Addendum No. M-02

Reference: Added Scope and clarification

Issue Date: November 6, 2024

Project: UHN TWH – SEM & Corridor (EXP Project Number MRK-23004289-A0)

LEVEL 1 FLOOR PLAN - NEW WORK - VENTILATION

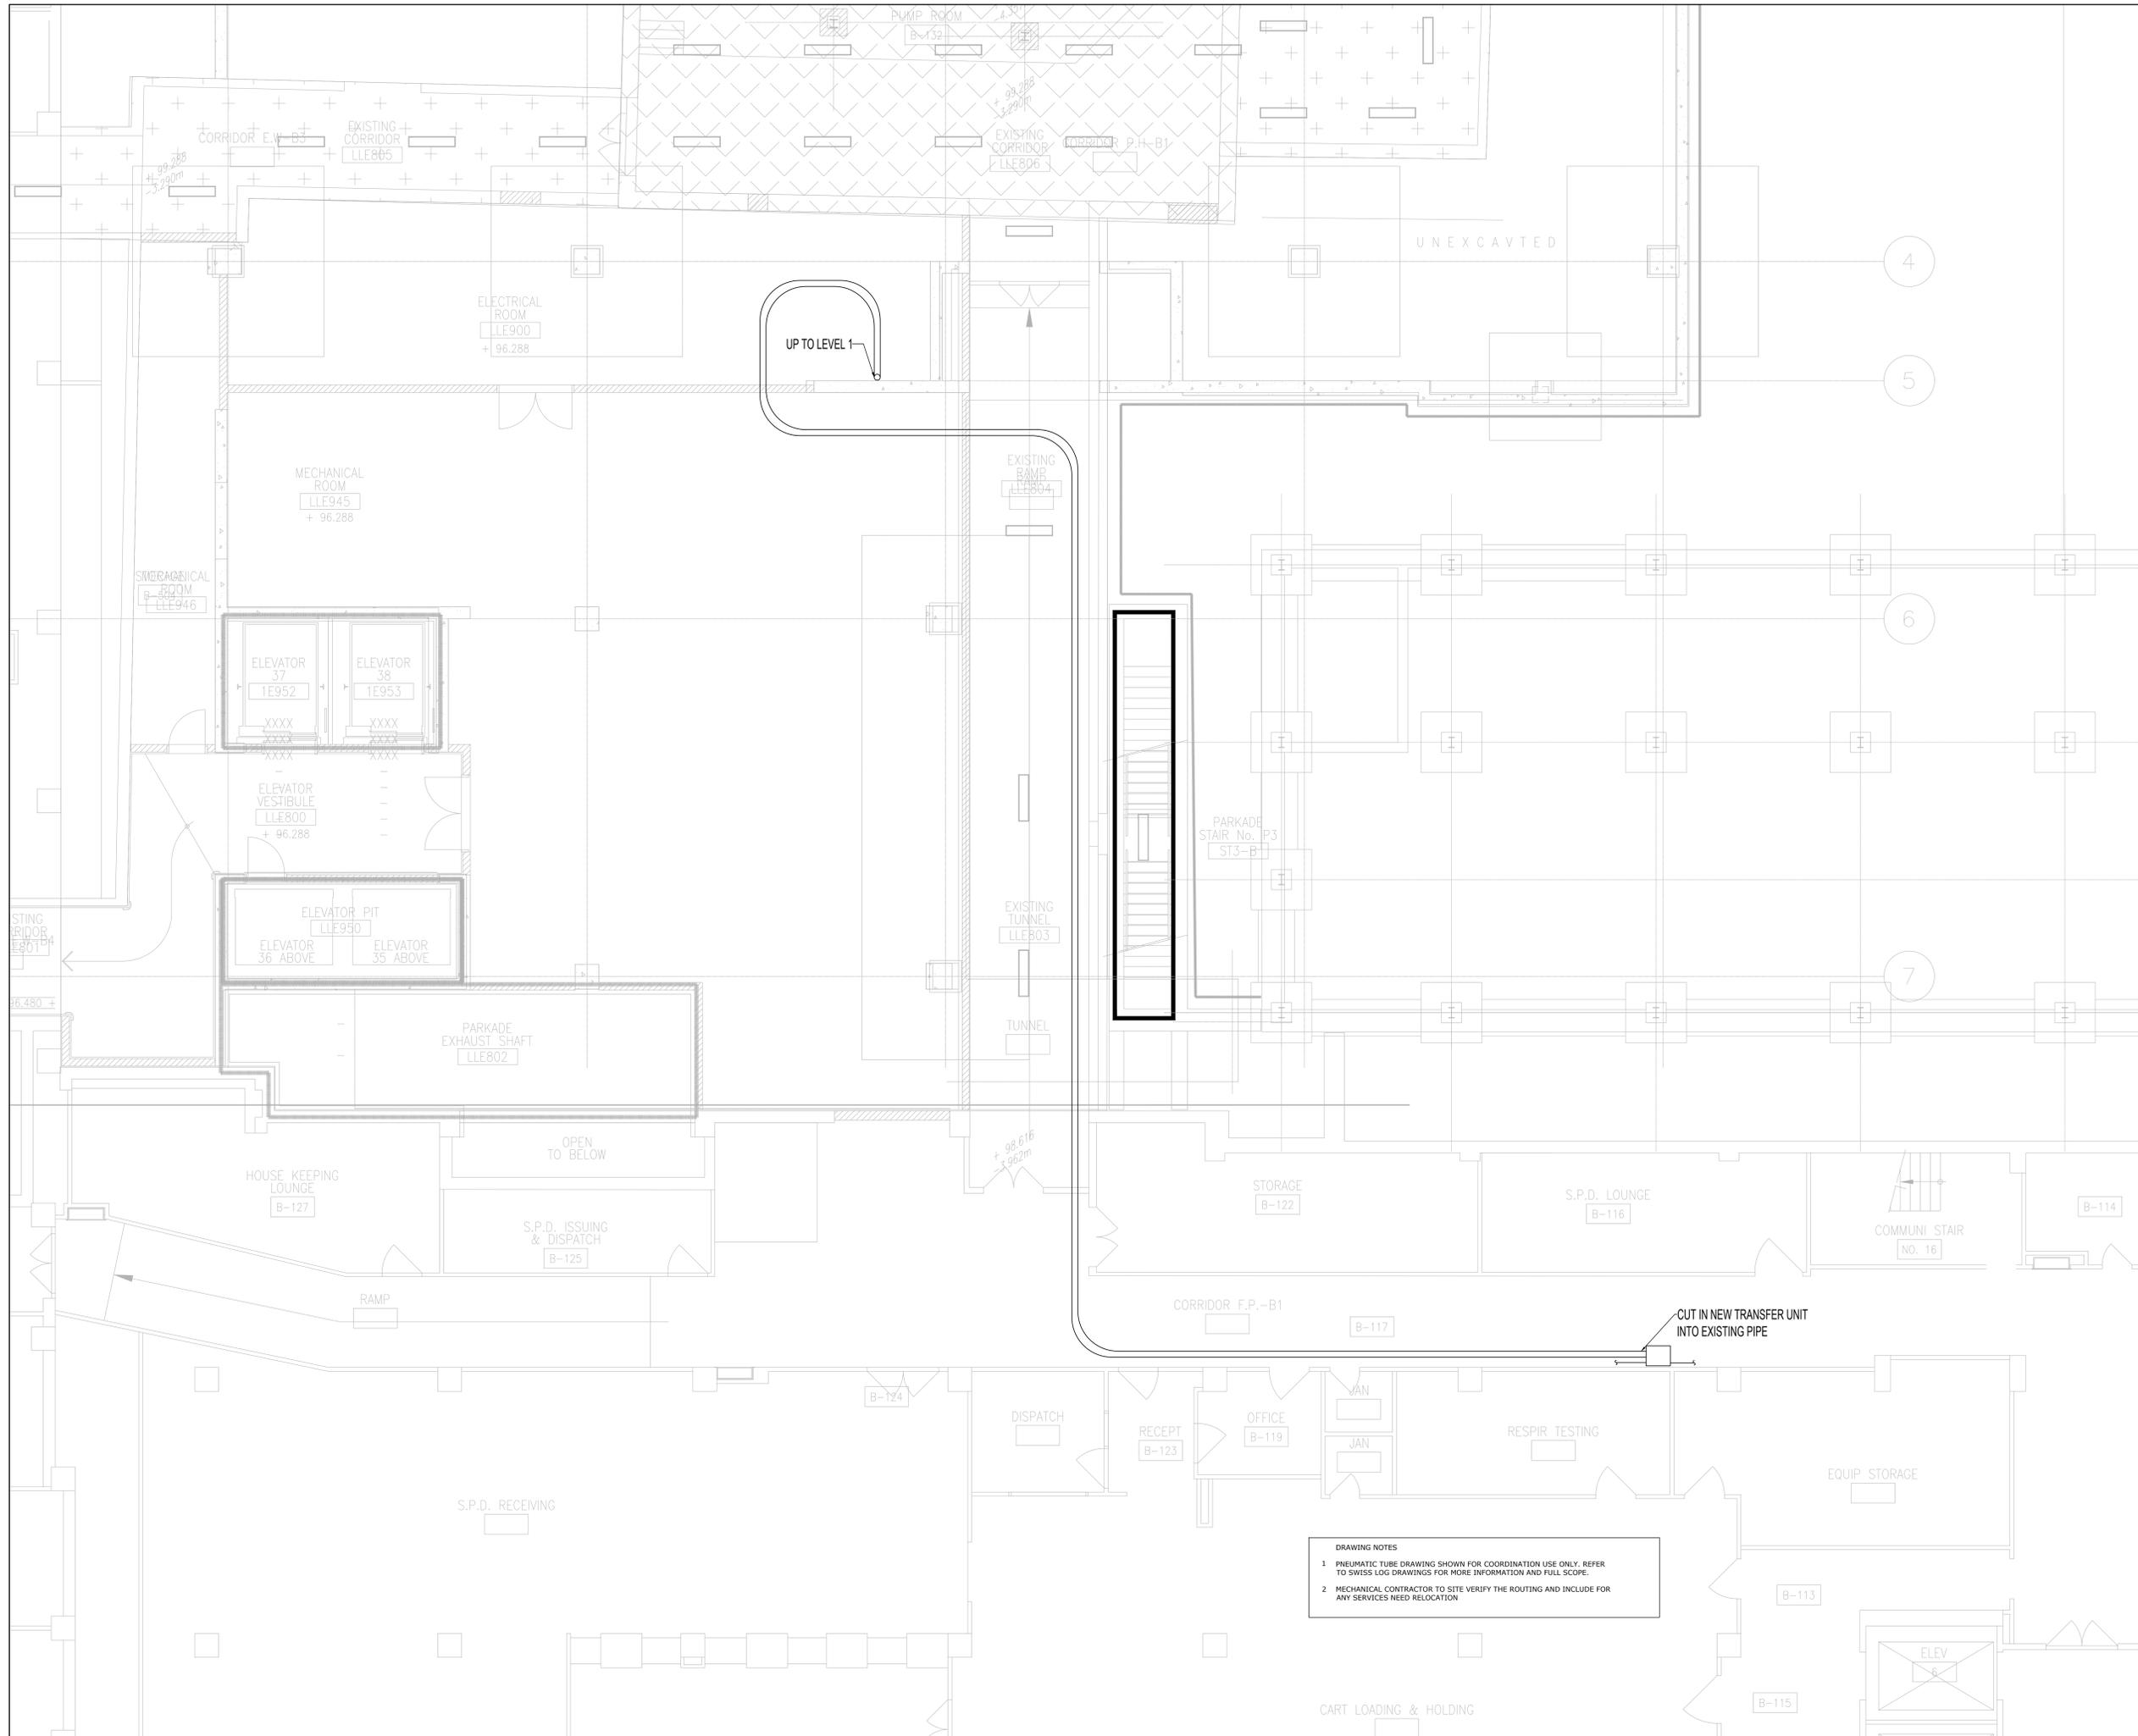
- 1.1.8. **M-211A – LEVEL 1 FLOOR PLAN – NEW WORK – VENTILATION**
- .1 Relocated transfer grilles and return grilles.
 - .2 Added airflow of existing VAV boxes.

- .3 Added drawing keynotes.
 - .4 Added duct size.
- 1.1.9. **M-211B – LEVEL 1 FLOOR PLAN – CORRIDOR – NEW WORK – VENTILATION**
- .1 Updated equipment size.

TITLE:
 BELOW GRADE FLOOR PLAN - NEW WORK
 - HVAC & PIPING

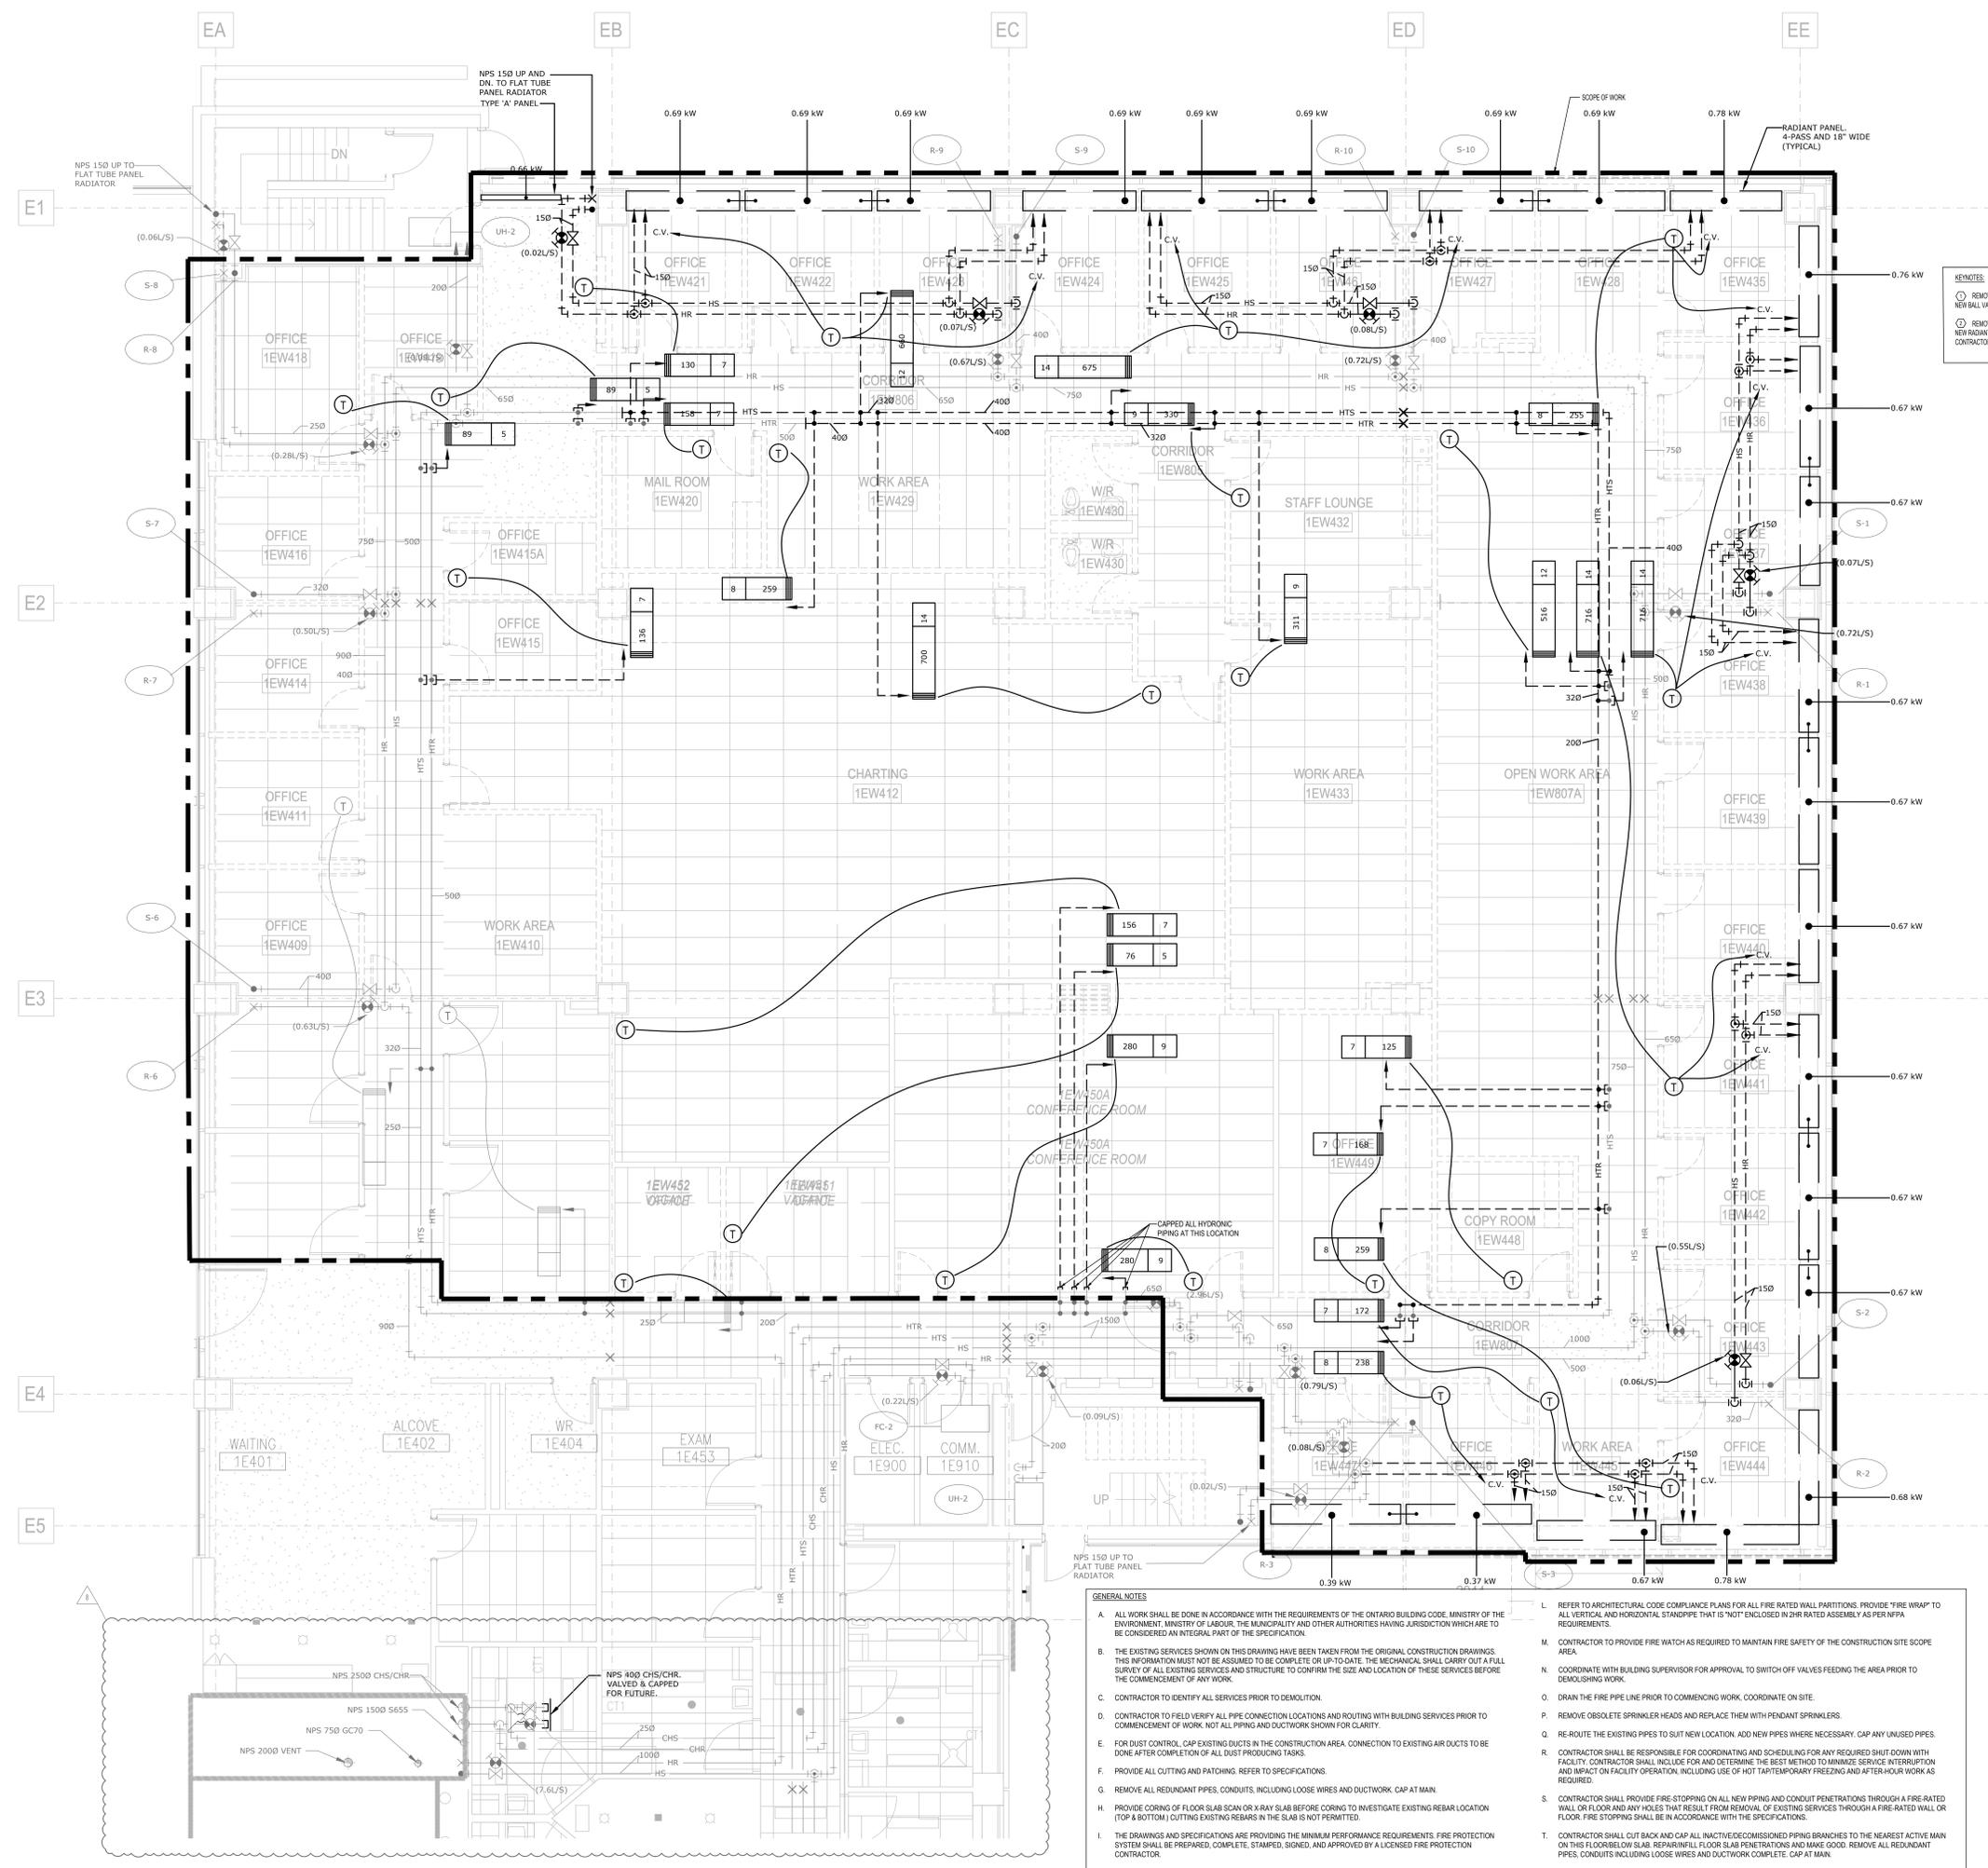
- .2 Update diffuser tags.
- 1.1.10. **M-300B – BELOW GRADE FLOOR PLAN – NEW WORK – HVAC&PIPING**
- .1 Updated the notes.
- 1.1.11. **M-301 – LEVEL 1 FLOOR PLAN – DEMO – HVAC PIPING**

LEVEL 1 FLOOR PLAN - DEMO - HVAC PIPING

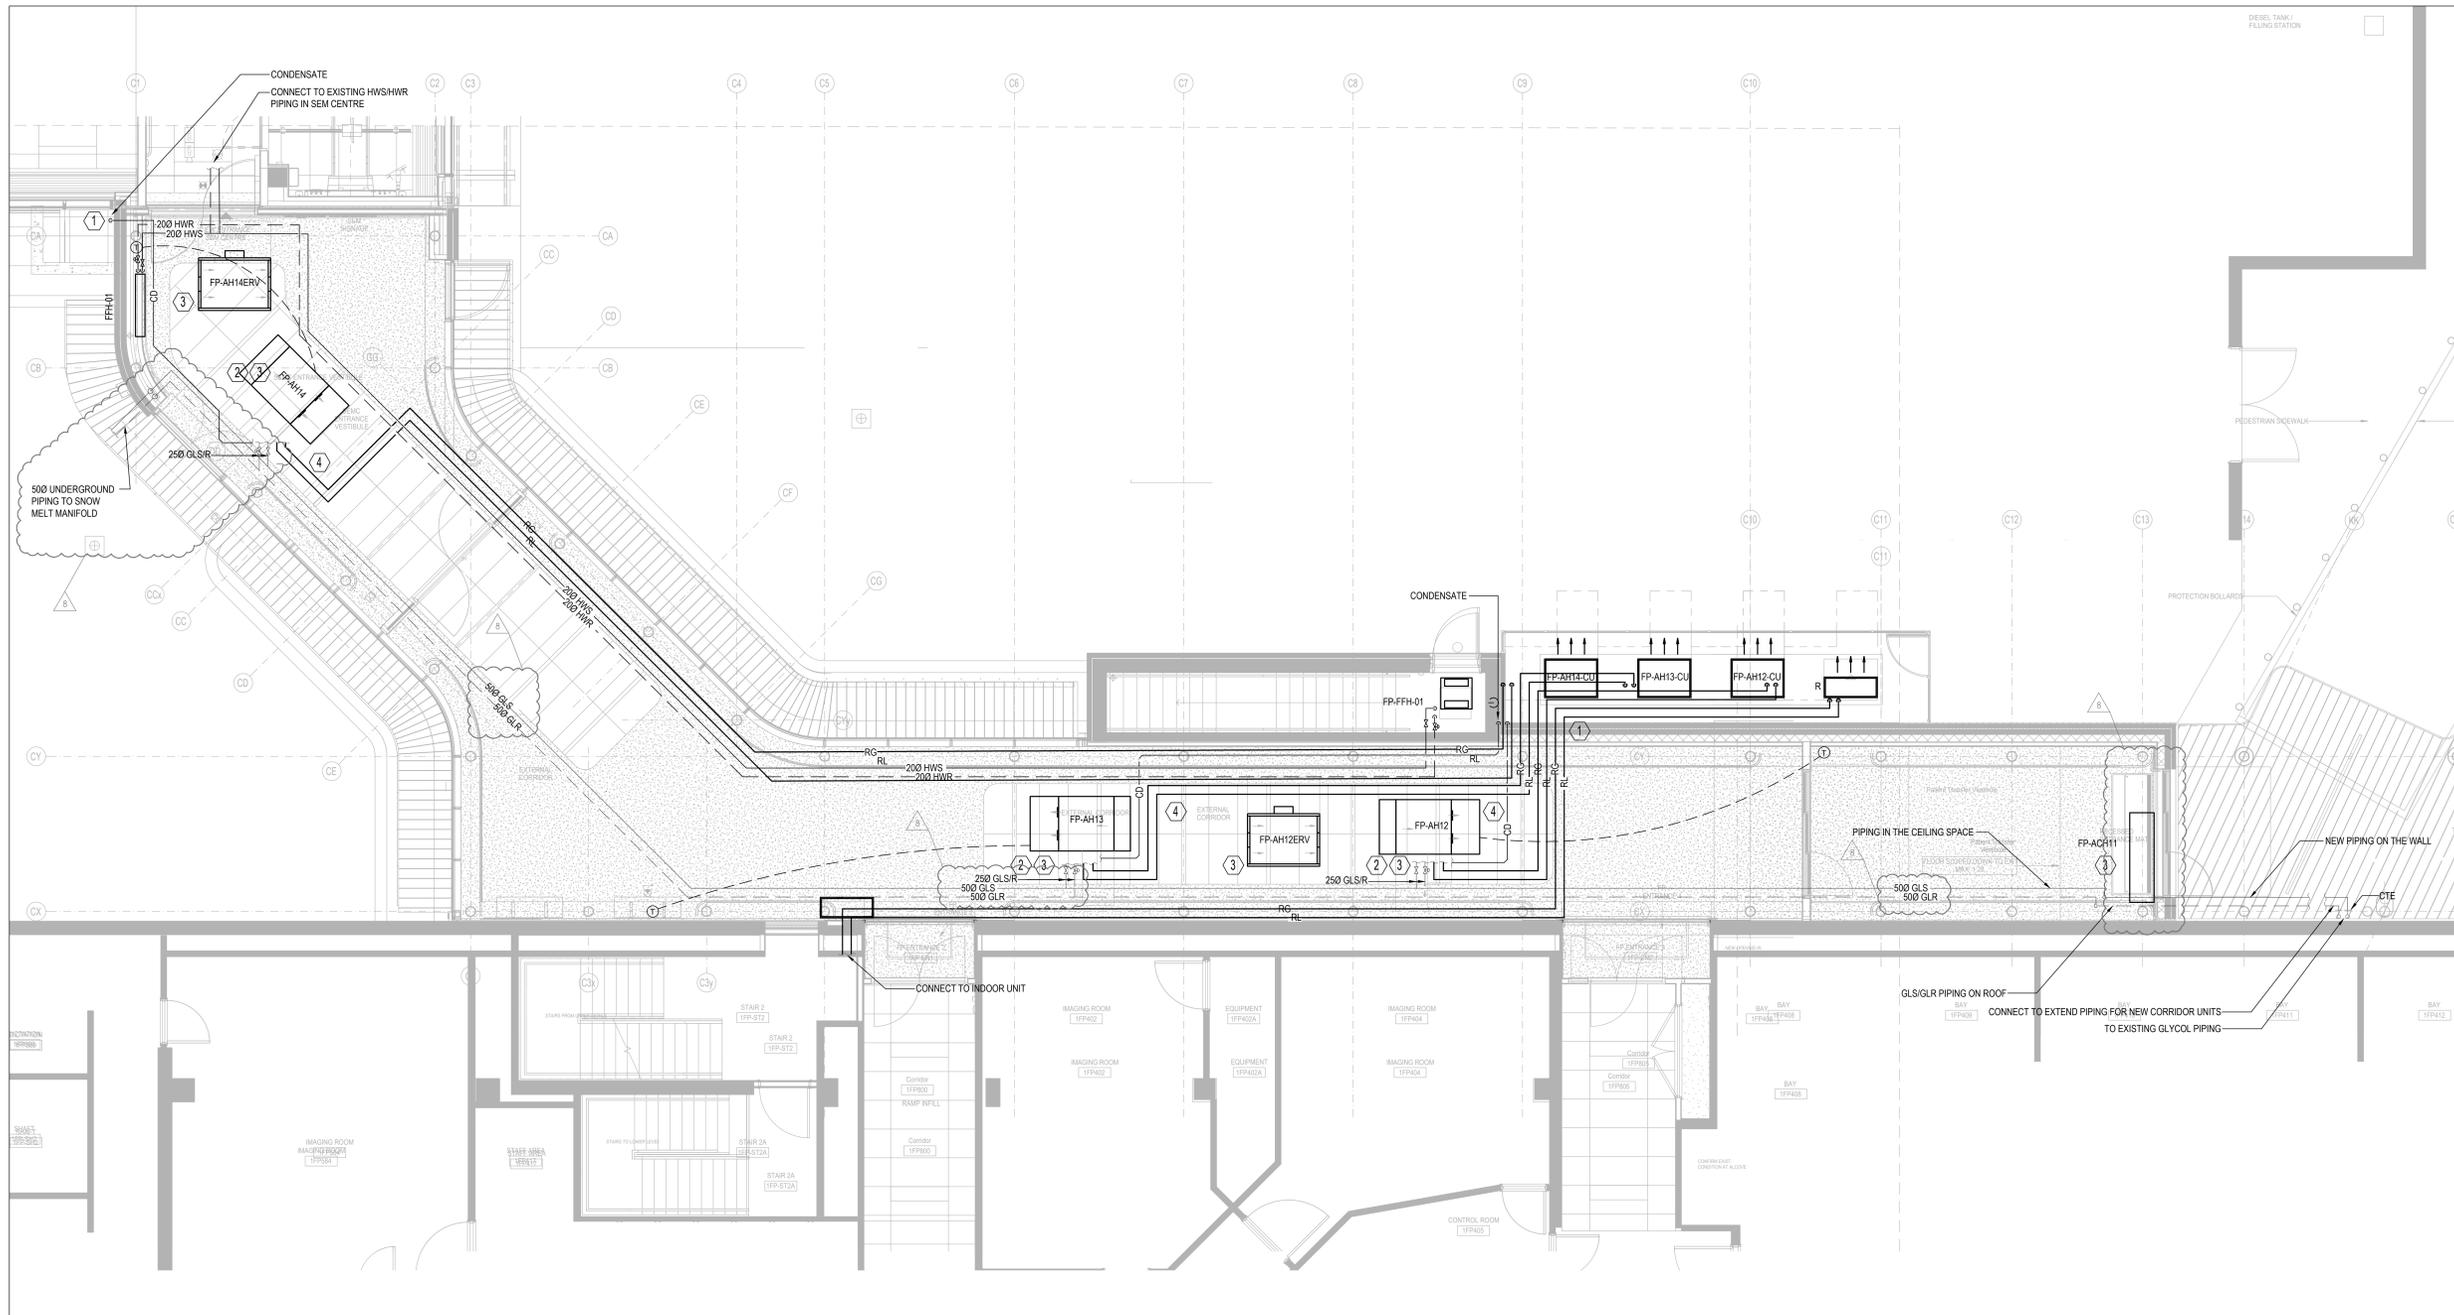
- .1 Added the arch background.
- 1.1.12. **M-311A – LEVEL 1 FLOOR PLAN – NEW WORK – HVAC PIPING**
- .1 Removed the notes.
